Project Name:	Coldharbour Farm Road, Emsworth
Document Reference:	187.0018/TN/1
Document Name:	Transport Note
Prepared By:	Mark Smith (May 2026)
Checked By:	Mark Smith (May 2026)
Approved By:	Mark Smith (May 2026)

TECHNICAL RESPONSE TO HCC HIGHWAYS COMMENTS

Road Safety Audit Report

Proposed Continuation of Coldharbour Farm Road Emsworth

DRAWING No: JUBB_XX_XX_DR_C_1200

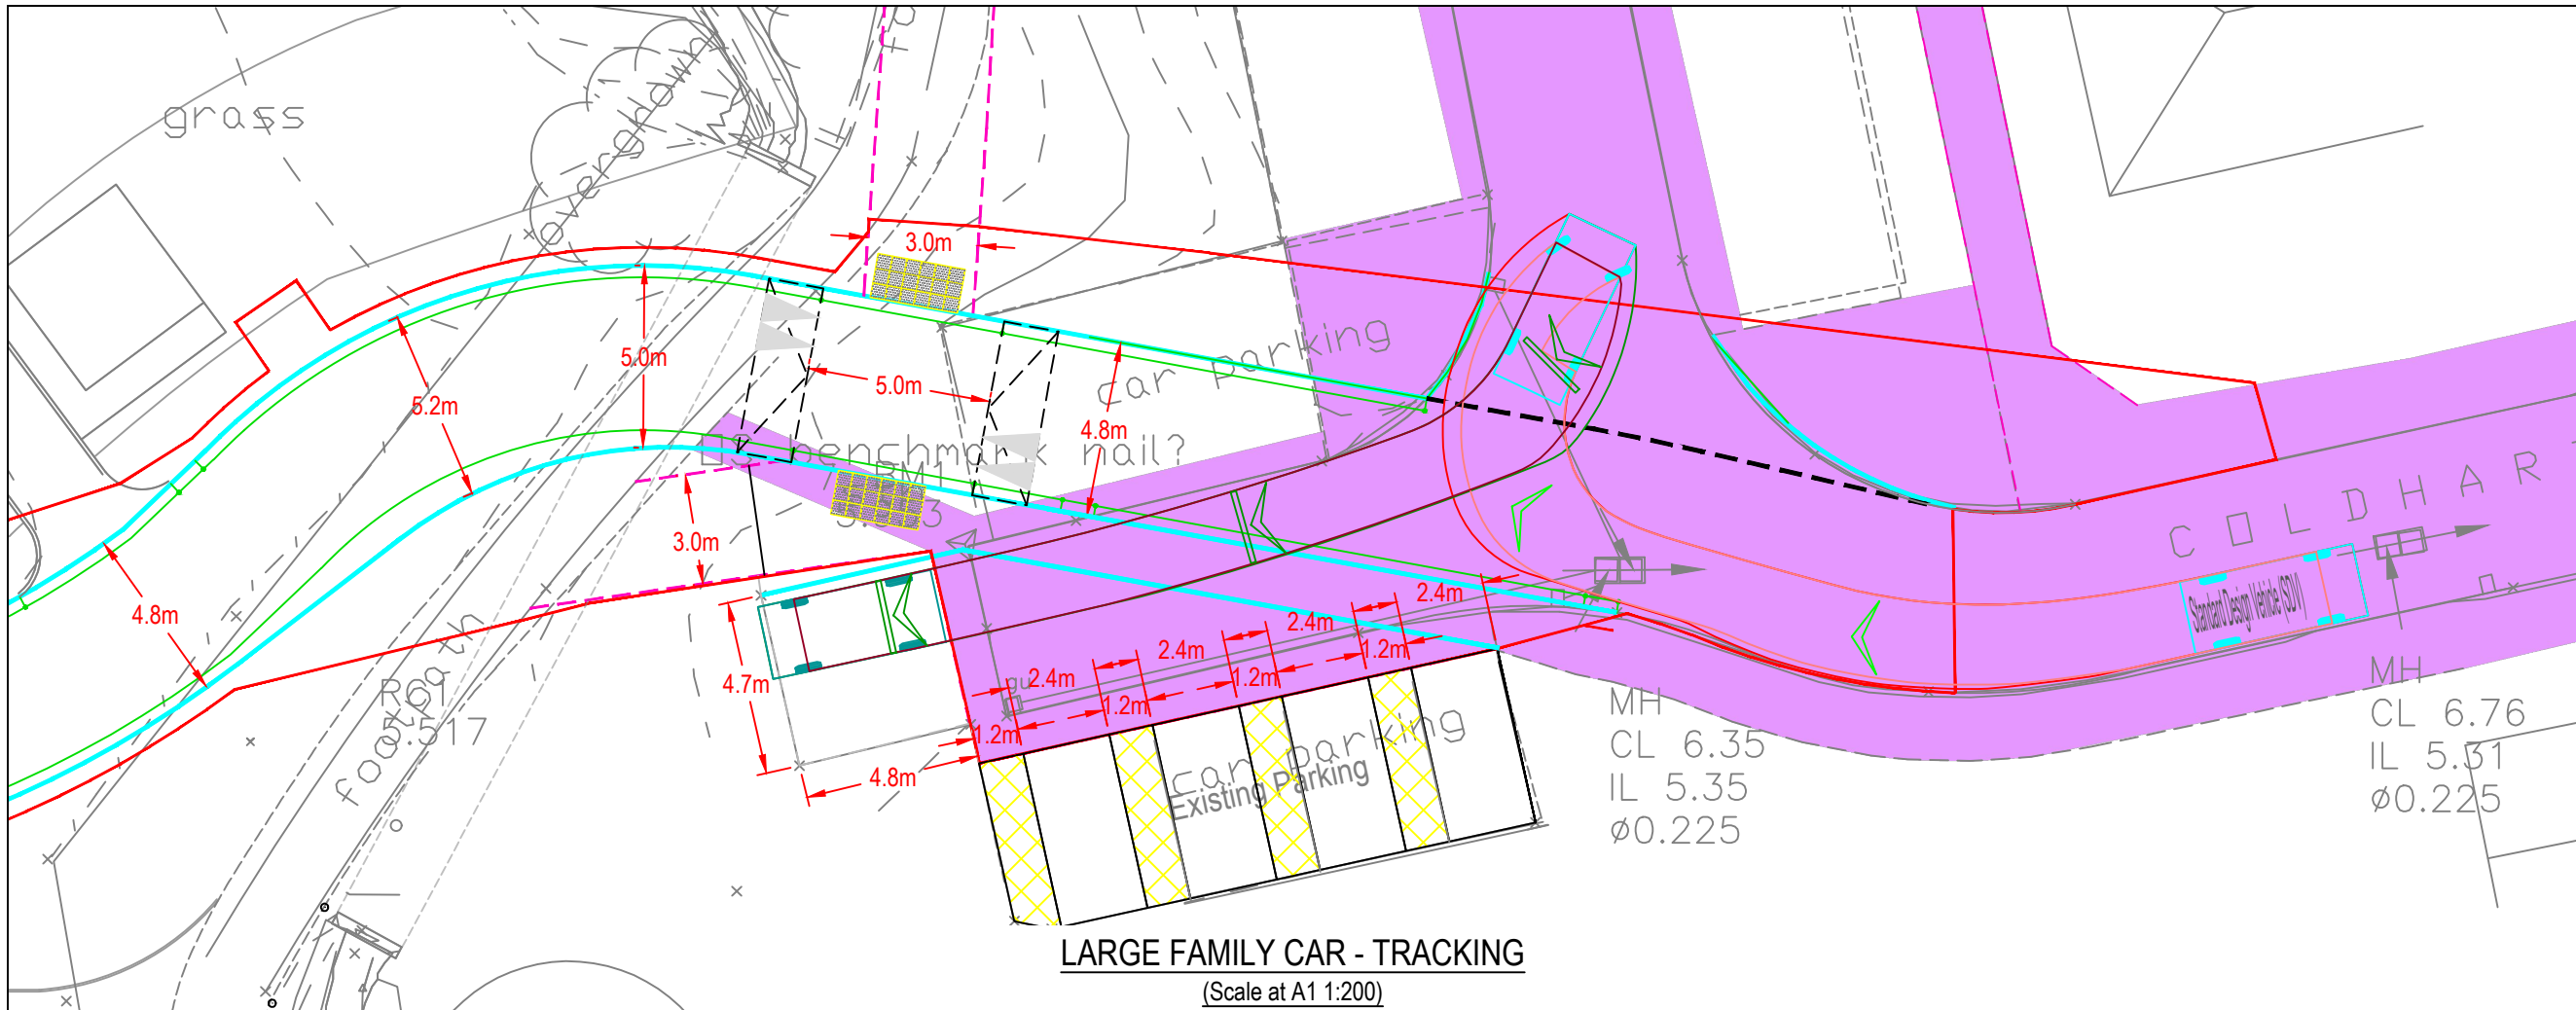
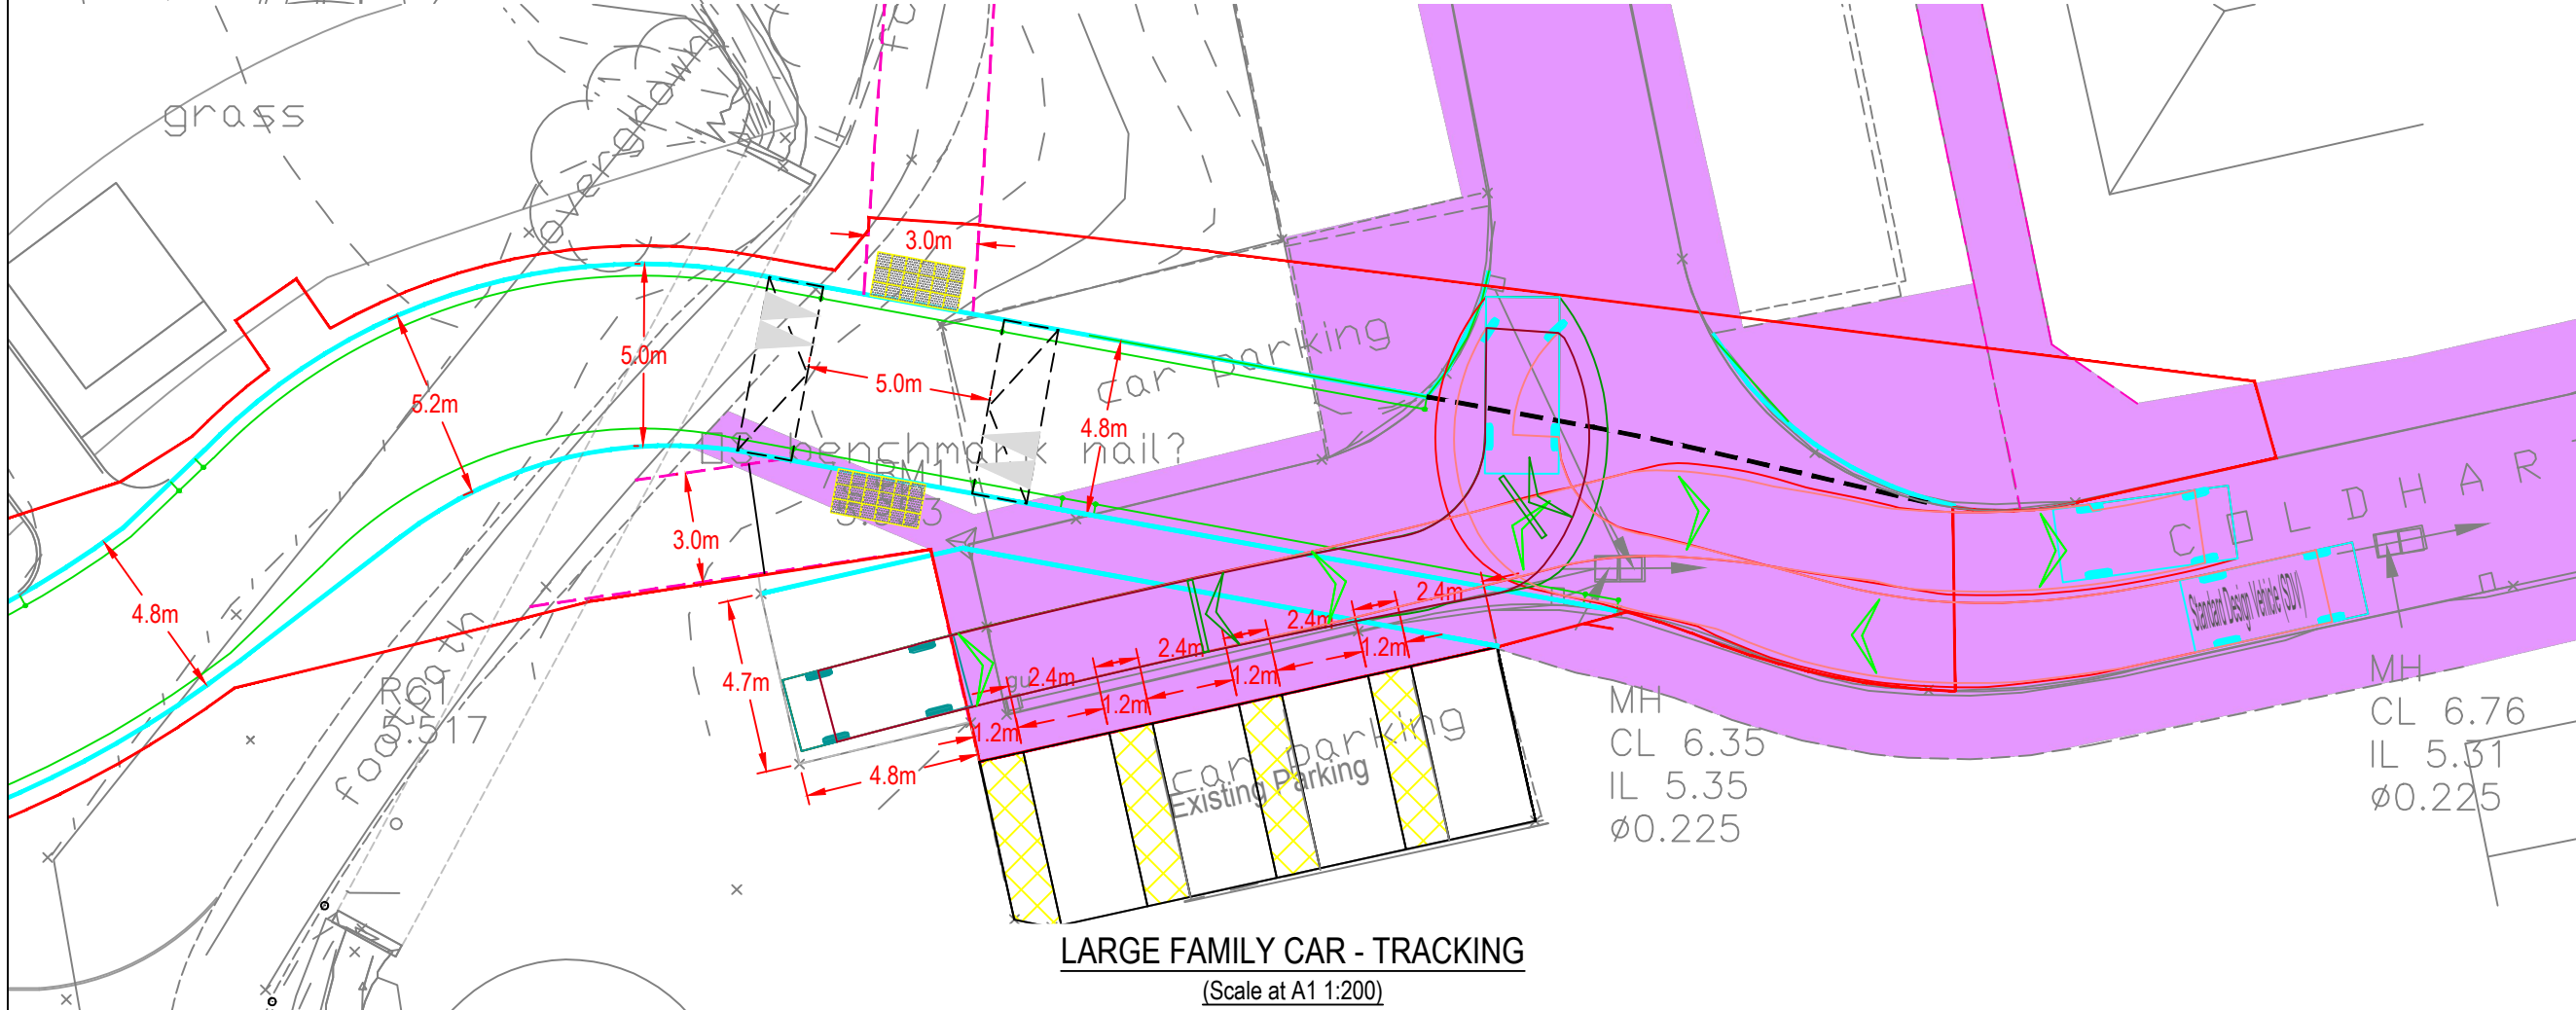
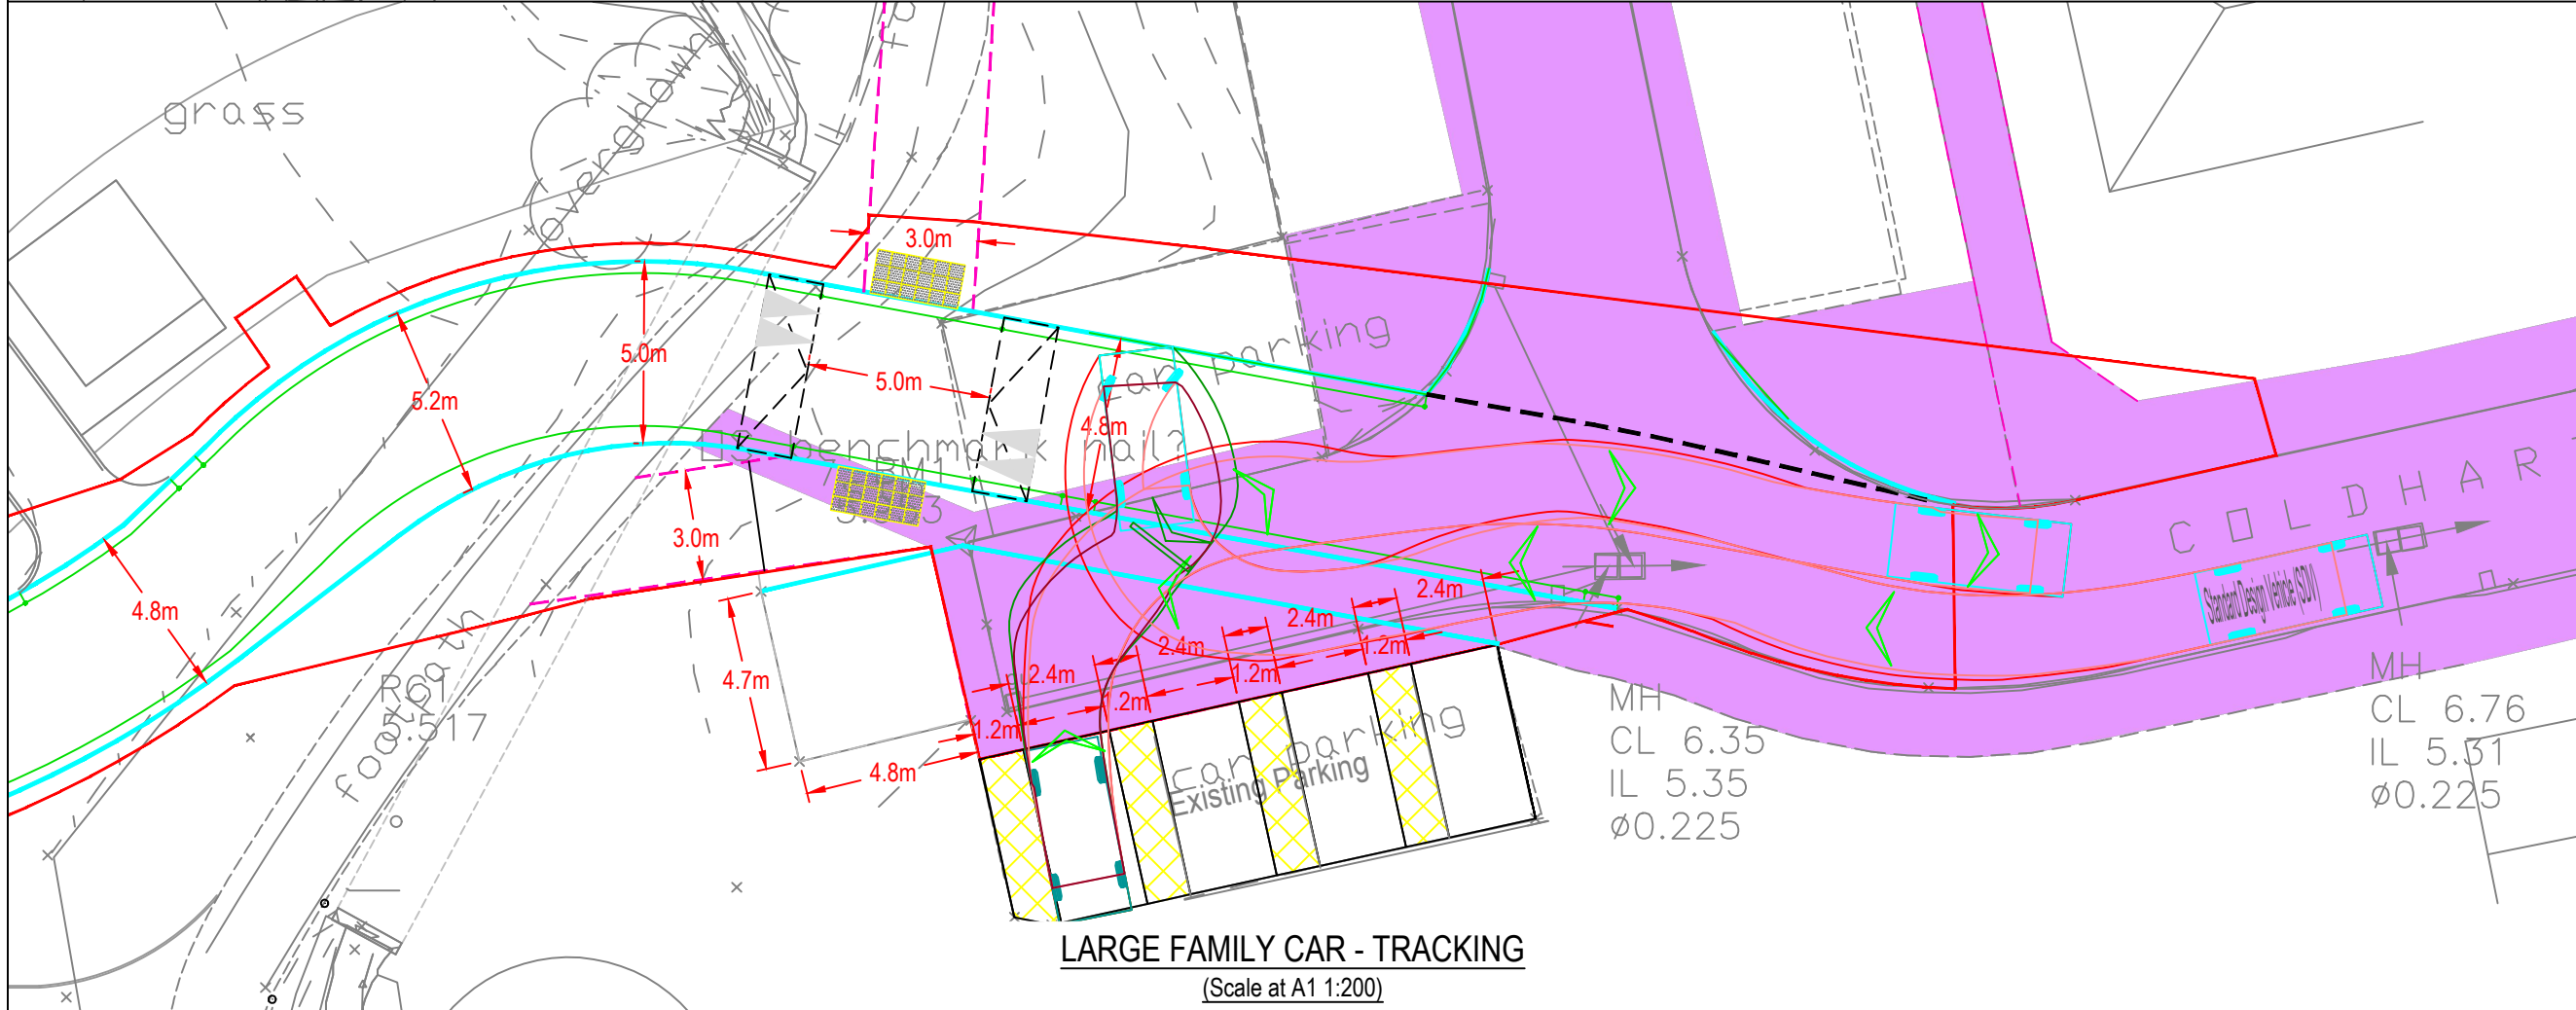
B.1.1 – Alignment may not be adequate for two-way car / LGV movements. It is recommended that the carriageway is adequate for cars and LGVs to pass one another.

We have provided updated tracking Drawing 23339-JUBB-XX-XX-DR-X-001200 REV C4 that shows in the bottom right that cars can pass each other.
